**WORCESTER TOWNSHIP PLANNING COMMISSION MEETING  
REMOTE MEETING  
THURSDAY, JANUARY 28, 2021, 7:30 PM**

Reference: 2625 Skippack Pike - Minor Subdivision

RE: **Traffic Review #2 – Residential Subdivision Plans**  
2625 Skippack Pike (LD 2020-06)  
Worcester Township, Montgomery County, PA  
McMahon Project No. 820978.11

Re: MCPC #20-0239-001  
Plan Name: 2625 Skippack Pike  
(1 lot comprising approx. 4.97 acres)  
Situates: Skippack Pike and Bethel Road  
Worcester Township

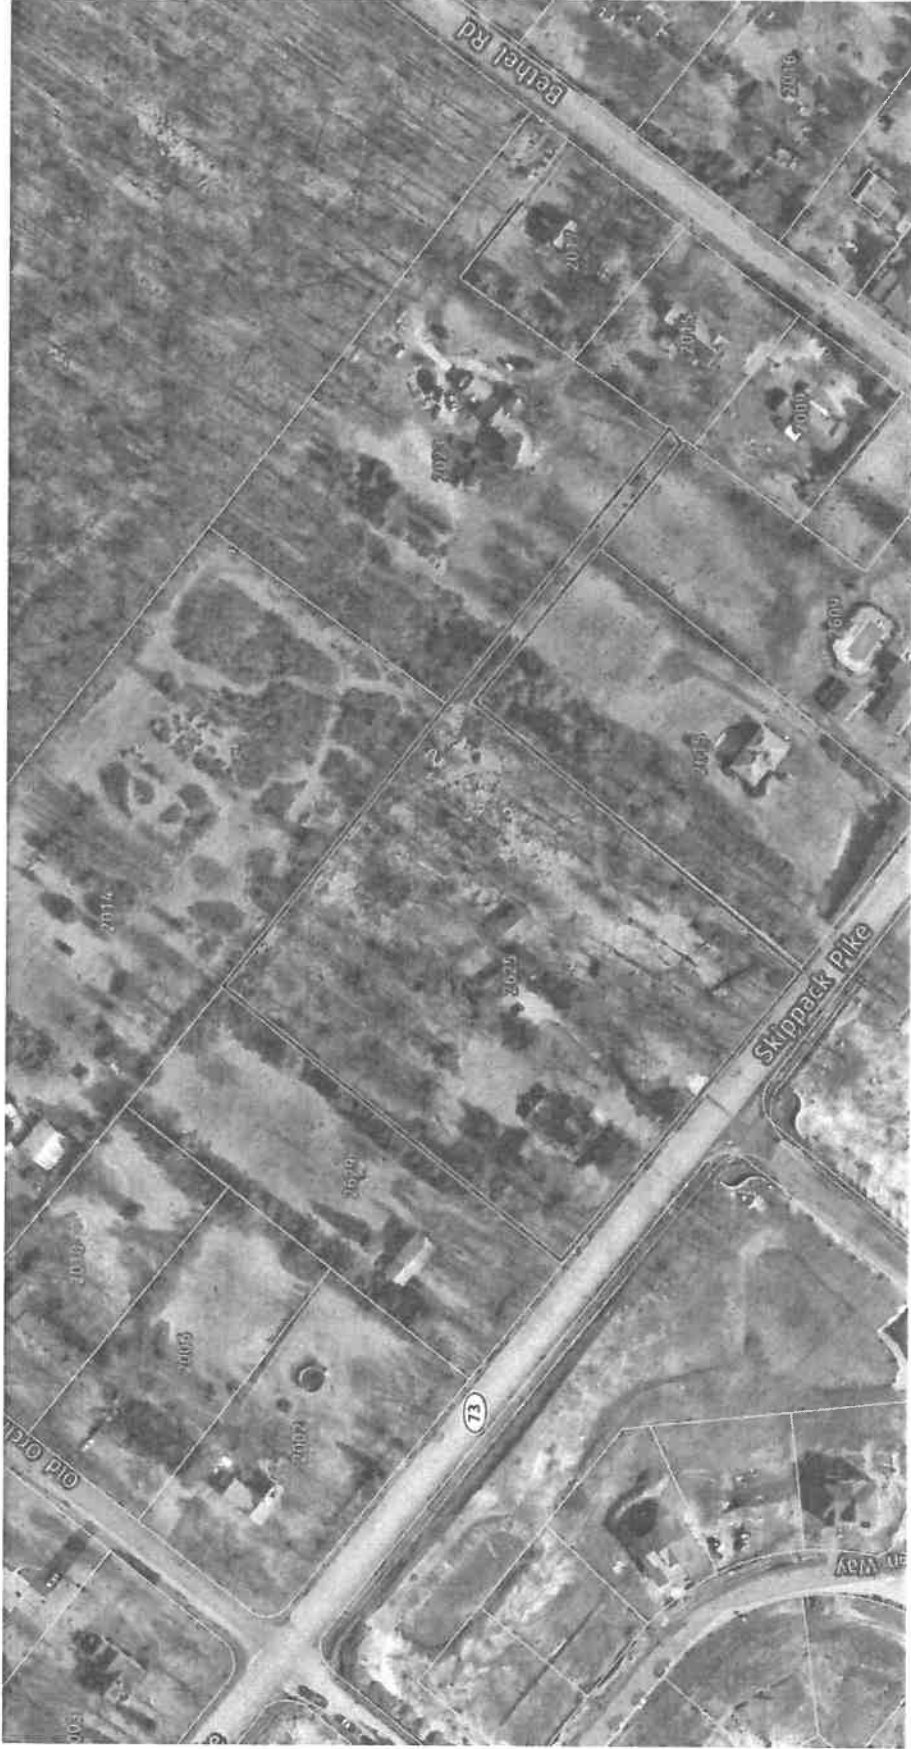
1. Setbacks. As per **§150-77.A.2** of the Zoning ordinance, private garages must adhere to the required setbacks of all principal buildings in the R-175 Residential District. At present, the existing garage on Lot 1, which is proposed to remain, will be within 13.8 feet from the side lot line of Lot 2, less than the 35-foot setback required of the zoning district for principal structures. While the existing dwelling on Lot 1 is a legal nonconformity as it pertains to front yard setback and is permitted to remain, rendering a previously-conforming garage nonconforming through a subdivision is not permitted. The Applicant should alter the proposed lot lines, or otherwise rectify the situation to the satisfaction of the Township.

2. SALDO Waivers. There are several waivers to SALDO requirements which will likely be requested by the Applicant; however, a list of which has not been provided for our review, so it is unclear what waivers are being requested and what requirements have simply not been met. Significant issues such as stormwater management, vegetation removal, and planting cannot be adequately assessed without the Applicant providing them at the time of subdivision approval. The Township should require the Applicant to provide these details or otherwise provide the refined list of requested waivers.

Attachment 1: Reduced Copy of Plan

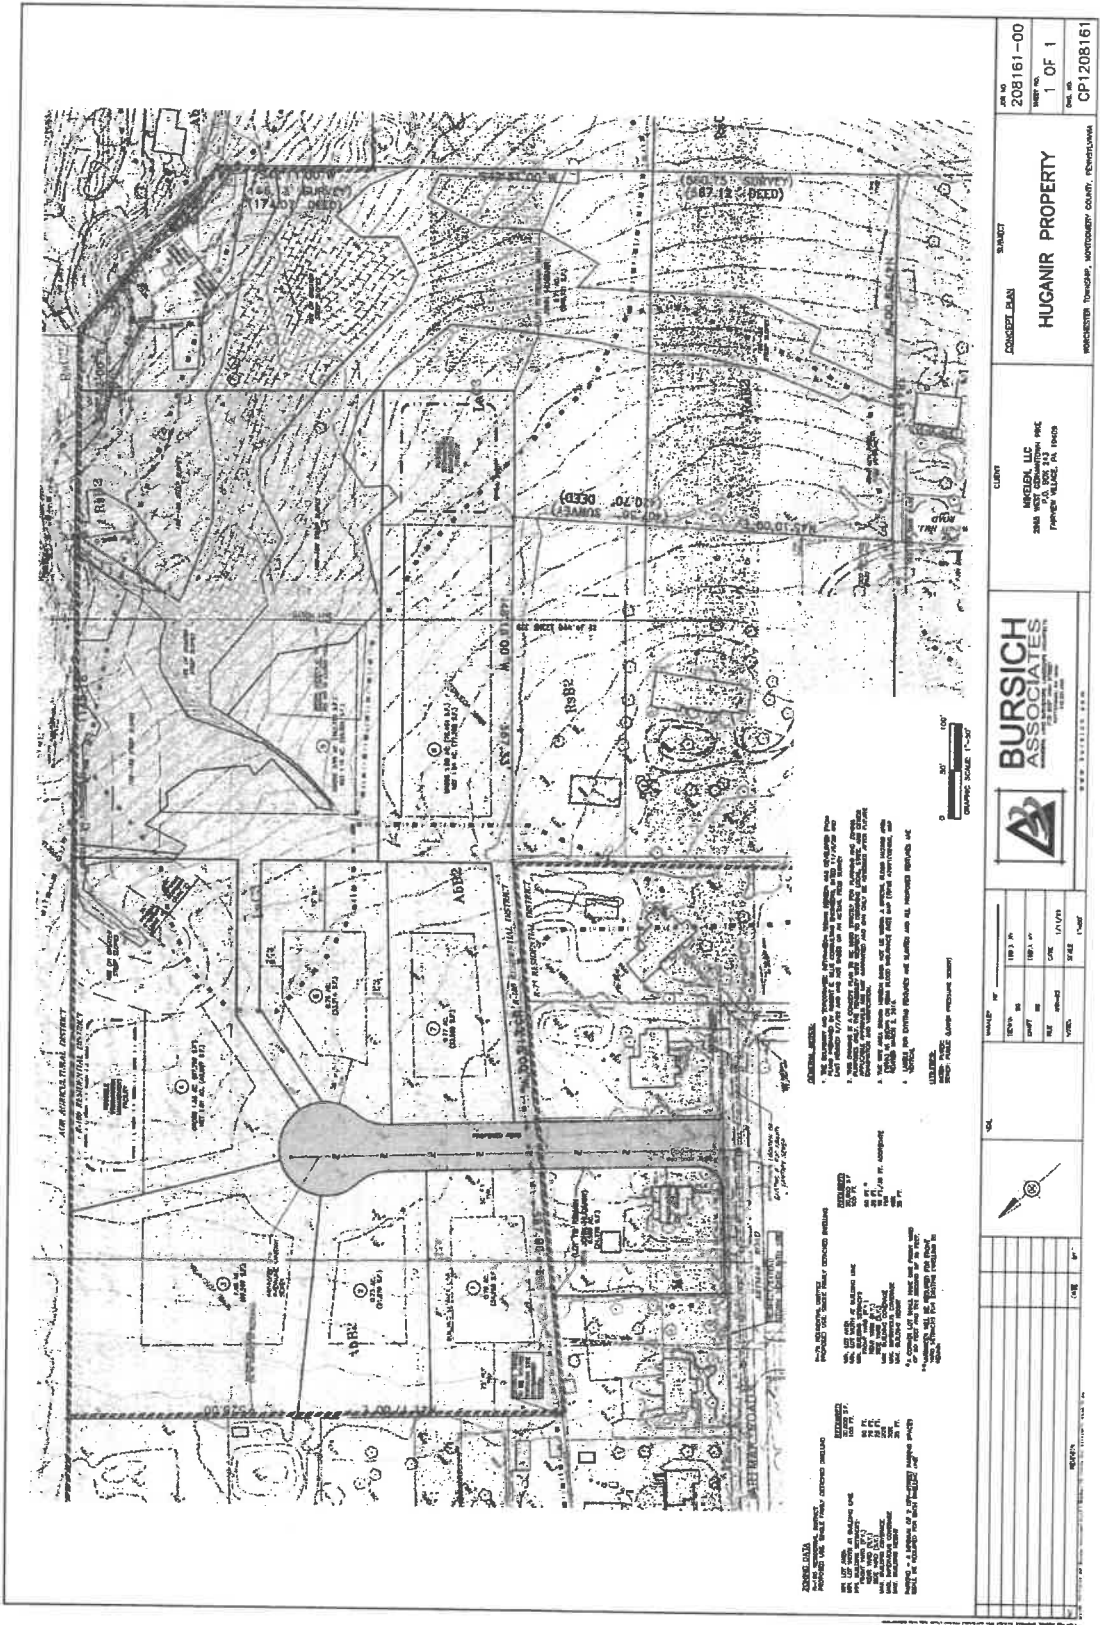
1. **Road Access.** As stated above, the Applicant proposes an access road to the Property, which currently does not have road frontage, through an existing house lot. However, there are several issues with the placement of the road. The proposed access road's proximity to the right-angle turn south in Artmar Road is not ideal, and may induce sight-distance issues. Moving the access road to the other side of the existing house may improve this. Additionally, adding more housing units onto Artmar Road will ultimately add more units to a neighborhood with only a single means of egress, which could be problematic—having a second means of egress, or different means of access entirely, may be preferable.

Judging from tax parcel maps, it appears that Windy Hill Road's right-of-way runs up the 17-acre parcel and up to the proposed Lot 8. Even if this right-of-way is abandoned, a new access road could be developed by extending Windy Hill Road up the parcel to service the new units.

2. **Cluster.** We acknowledge that the existing zoning of the site does not permit a cluster-type development. However, the Township may have an interest in limiting disturbance of the dense vegetation and steep slopes on the site. If one were to assume that the property was zoned AGR Agricultural zoning (the same as adjacent parcels to the north), using Option 1 of the Conservation Subdivision provisions in the Zoning could yield roughly the same unit count to what is being proposed here.
3. **Plan Artifacts.** There appears to be a number of items on the plan for which more explanation would be needed—for example, a large square within Lot 5 has an illegible description. These should be described more fully.

1. **Front Yard.** As currently proposed, the creation of the access road to the development diminishes the size of the existing housing lot on Artmar Road, and effectively makes this interior lot a corner lot, with two front yards. The second front yard setback created by the new road creates a zoning nonconformity where none previously existed. To continue with the development in this manner would require either a variance for the front yard setback or, alternatively, the removal of the existing house.

2. **Steep Slopes.** The plan indicates steep slopes on the site according to the SALDO thresholds of 10% and 18% grades. However, the Zoning Ordinances defines steep slopes by the thresholds of 15% and 25% grades. This should be added to the plan.

3. **Riparian Corridor and Wetlands.** Though faint, there also appears to have been existing wetlands delineated on the plan to the north—these should be described more fully, and appropriate setbacks should be illustrated on the plan. There may also be an unmapped stream which runs northwest through Lot 5 northwest (through the wetlands described above), connecting with the larger stream to the north, which may also require a riparian setback.
